Our ref: B-0939-220-01_Rev2

16 December 2022

Re: Bowdens Silver - Geochemistry Peer Review

Figure 1: Recommended initial sampling frequency based on tonnage (Price 2009).

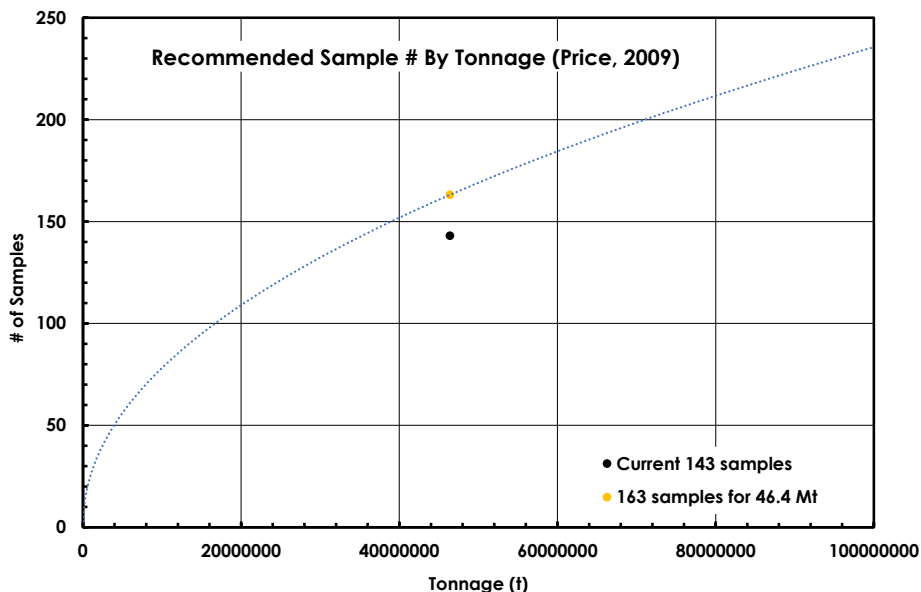
The guidance provided in the *Prediction Manual for Drainage Chemistry from Sulphidic Geology Materials* (Price, 2009)³ is commonly used by industry for determining an initial sampling rate for geochemical characterisation of mine wastes when sampling without prior information. It should be noted that the Project has been in development for several years and over this time substantial data has been collected on both the deposit and the surrounding waste materials. Hence, the waste classification system developed for Bowdens Silver was completed with the benefit of information gathered over an extensive time frame. The existing geological knowledge base was leveraged during development of the waste classification system. Using this guidance, an appropriate number of initial samples for an anticipated volume of 46.6 Mt of mine rock is 163. The current number of samples on which acid base accounting (ABA) has been completed is 143, only 20 less than the guidance suggests (Figure 1).

Okane considers the current number of samples used to determine AMD risk is appropriate for this stage of the Project.

Figure 2: Semi-variogram plotting for the domain with TS < 0.3% at 5 m composites (bench and block scale with additional drilling since EIS), Bowdens Silver, 2022; axis aligned variograms for TS are summarised in the left panel, major and minor axis variograms are plotted in the right panel).

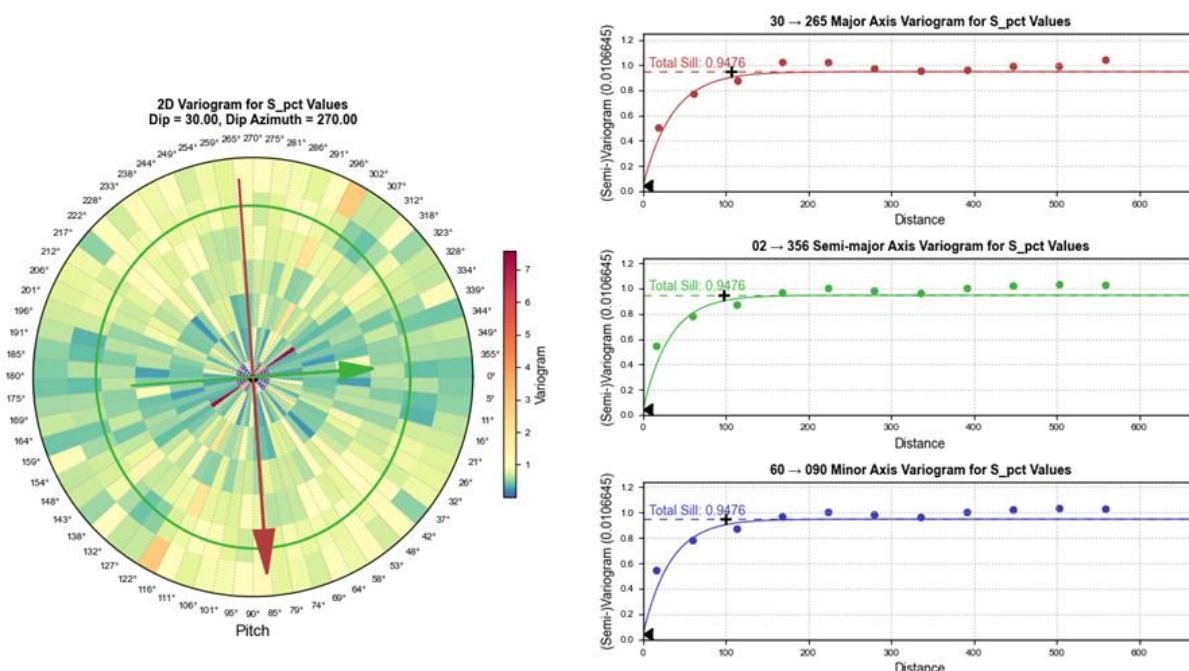
- b. the domain with TS > 0.3% also has less variability, or relative homogeneity, with a CV of 0.94; and
 - c. semi-variograms for the domain with TS < 0.3% at 5 m composites points to a relatively homogeneous Bowdens Silver deposit with a variance less than 1.0 and a correlation range around 100 m (Figure 2).

Figure 3: Cross section of the main pit and TS contours (0.1% (black line), 0.2% (red line) and 0.3% (blue line) with pit and dacite (pink) below pit showing the spatial relationship and TS zoning around the dacite, from Bowdens Silver, 2022).

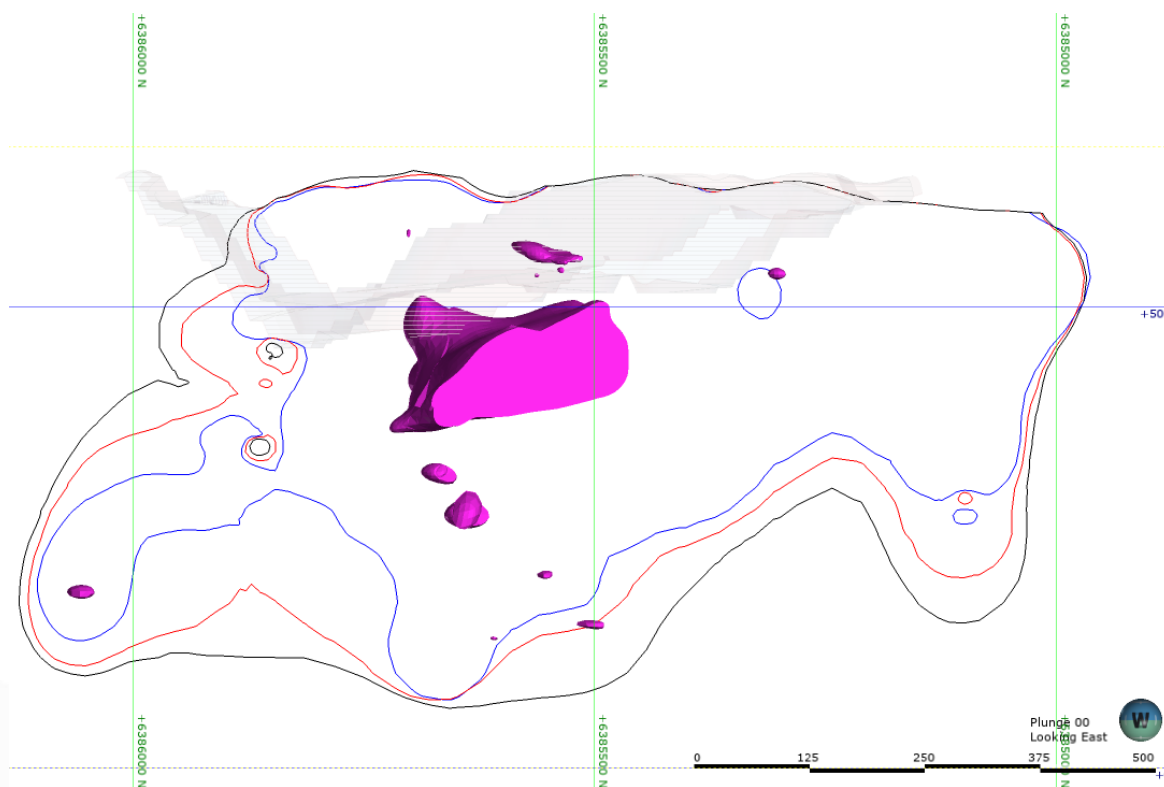
- 1) The hydrothermal alteration zoning is a highly influential characteristic of the Bowdens Silver deposit. Figures 3 and 4 below show the hydrothermal alteration zones are represented by illite

crystallinity zones (Figure 4) and TS zoning is around the hydrothermal alteration zones (Figure 3). Therefore, using such a prominent nature feature to assist AMD risks classification is a great advantage in material characterisation, also an expression of high level understanding the geological and geochemical characteristics of the Bowdens Silver deposit, which control the sulfide distribution in space.

Figure 5: Bowdens Silver sampling scheme followed the hydrothermal alteration zones (the PZ indicates primary zone and WZ for weathered zone, from Bowdens Silver, 2022).

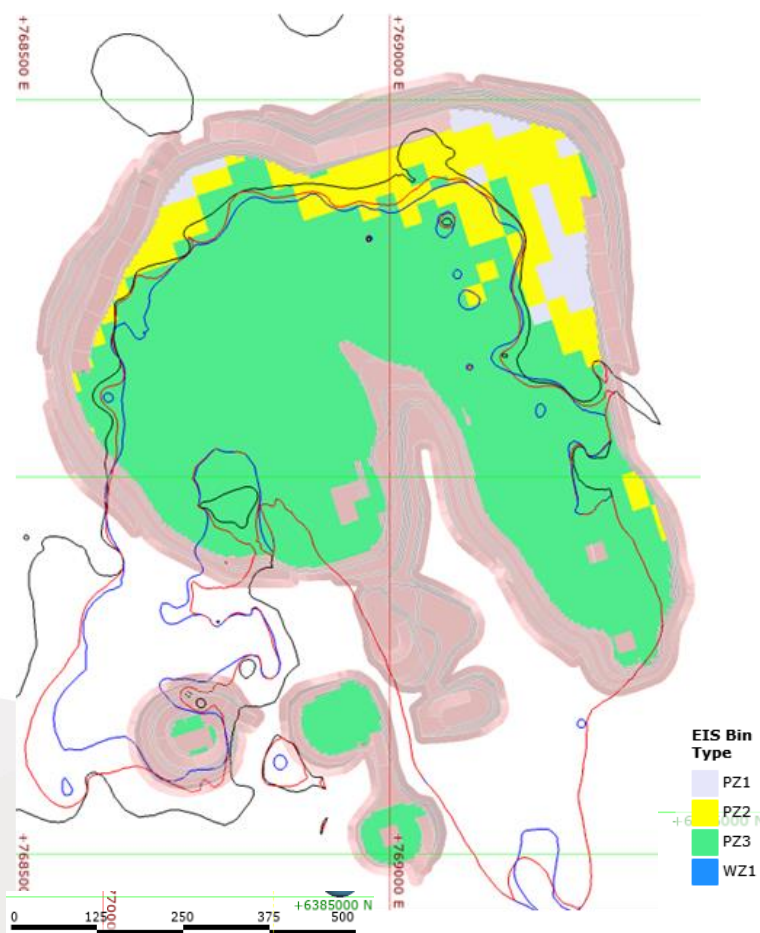
- 2) Although only five samples with complete ABA analysis were collected in the northern section of the proposed main pit, there are many other samples in the same hydrothermal alteration zone from the other areas of the main pit, which have had complete ABA analysis undertaken. From the perspective of sulfide (Figure 3), which is controlled by the hydrothermal alteration zone (Figure 3 and 4), all samples collected in the same zone represent and contribute to characterisation of the whole zone. That is, the objective of the HAZ method is to fully characterise each hydrothermal alteration zone. The sample frequency for a certain locality is not as critical as it is when using the lithology method because samples from other localities can provide representative data for AMD risk assessment based on the targeted common feature, i.e., the hydrothermal alteration zone (Figure 5).

Figure 6: Correlation of TC and TCC for the samples with TS < 0.3% (new data provided by Bowdens Silver (2022) confirms that TCC comprises the dominant carbon species in TC).

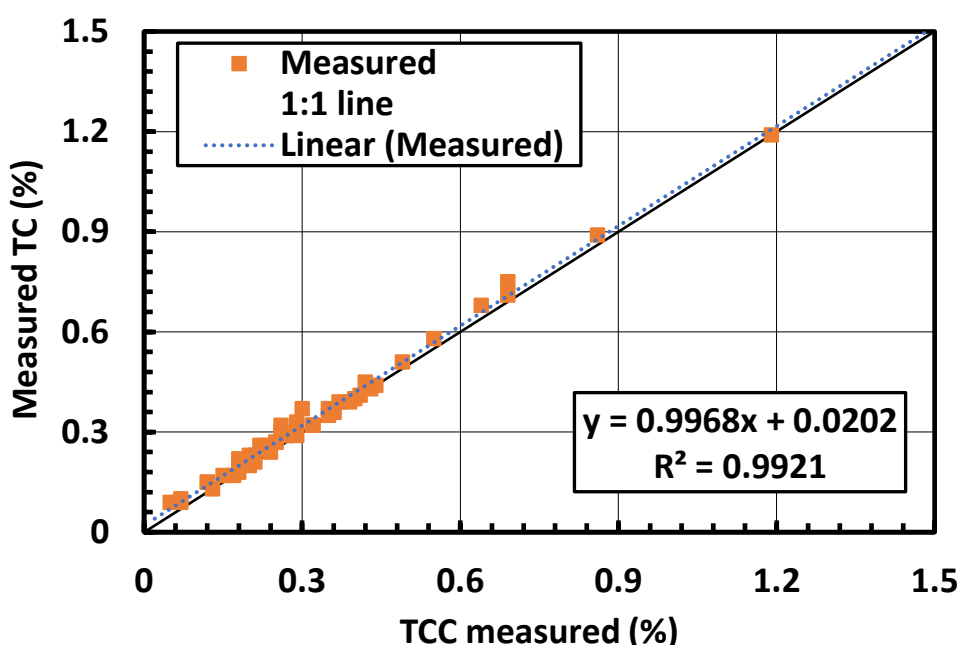
Upon receipt of additional data from Bowdens Silver relating to this recommendation, Okane examined the correlation between TC and TCC. Figure 6 shows a high correlation between TCC and TC, with trend of almost 1:1. This confirms TCC is the dominant carbon species in TC.

Figure 7: Scatter plot of TCC vs. TS for samples with TS < 0.3% (new data provided by Bowdens Silver (2022); black line in the range of 0 to 0.3 % stands for the 1:1 line between TCC and TS).

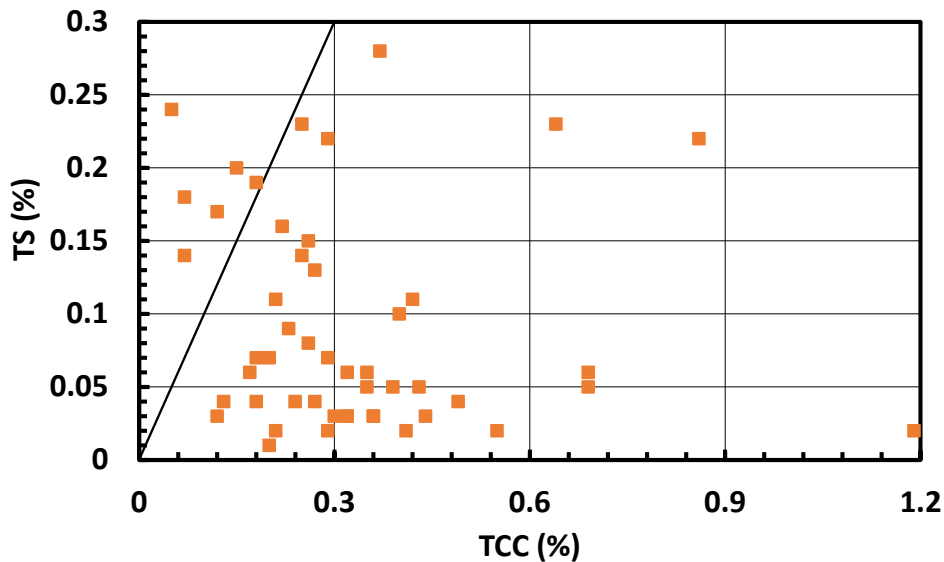
A scatter plot of TCC against TS was generated to examine the relationship between TC and TS (Figure 7). No correlation between the TCC and TS was observed, with TCC content generally much larger than TS for most samples (90% on the right-hand side of the 1:1 line). This means it is reasonable for these samples to use a 0.3% of TS cut-off value is considered reasonable where $TS < TCC$ as the TCC will provide sufficient ANC to buffer acidity generation. Approximately 10% of the total samples had a TS content slightly larger than TCC content (left of the 1:1 line). This indicates these samples with relatively less carbonate (0.09 – 0.18%) and slightly more sulfide (0.14 – 0.24%), are unlikely to provide enough ANC to offset acidity generation, though at very small amounts.

Therefore, a 0.3% of TS cut-off value should only be used for samples on the right-hand side of the 1:1 line for TS and TCC. That is, the 0.3% of TS cut-off value can only be safely used for the samples with $TS < TCC$, and not for the samples with $TS > TCC$. A $TS < TCC$ is the safe boundary for applying a 0.3% of TS cut-off value in the Bowdens Silver deposit.

Figure 8: TCC Calculated by Ca-Mg algorithm are well correlated with TCC measured (also highly correlated with measured TC; black line is the 1:1 line for the measured TC and TCC measured, dashed line is the trend line for TCC calculated and TCC measured).

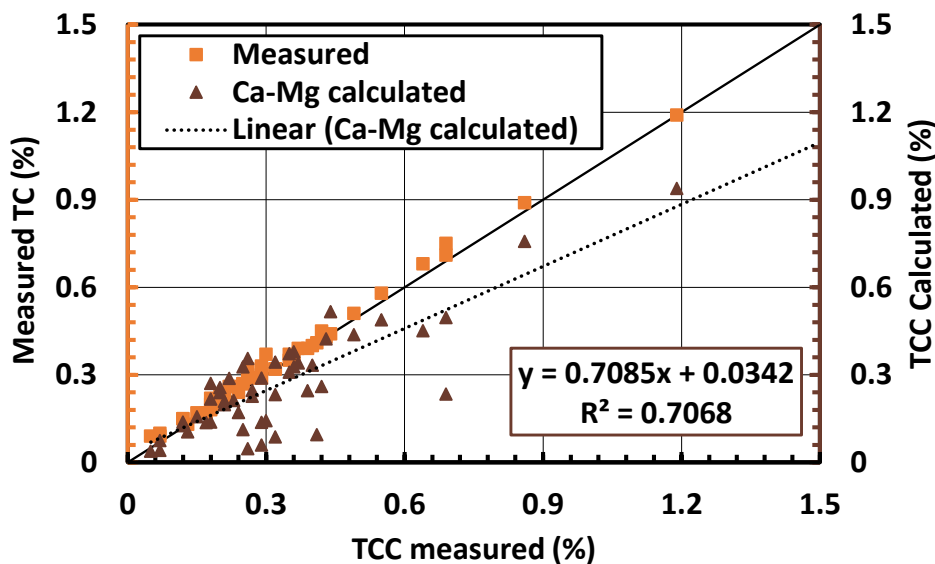
The correlation analysis between TCC and whole rock Ca, Mg, or Ca+Mg indeed show positive correlation among these items with a correlation coefficient R^2 around 0.6 to 0.7 (Bowdens Silver, 2022). On the other hand, based on the new data provided by Bowdens Silver (2022), the correlation between measured and calculated TCC was examined in Figure 8, where calculated

TCC is well correlated with the measured TCC, with 0.71 of correlation coefficient R^2 , whilst nearly half of the samples are plotted to the right side of 1:1 line. This implies that the Ca-Mg algorithm seldom overpredicts the measured TCC. Therefore, it confirms the Ca-Mg algorithm is useful in AMD risks assessment for the Bowdens Silver deposit.
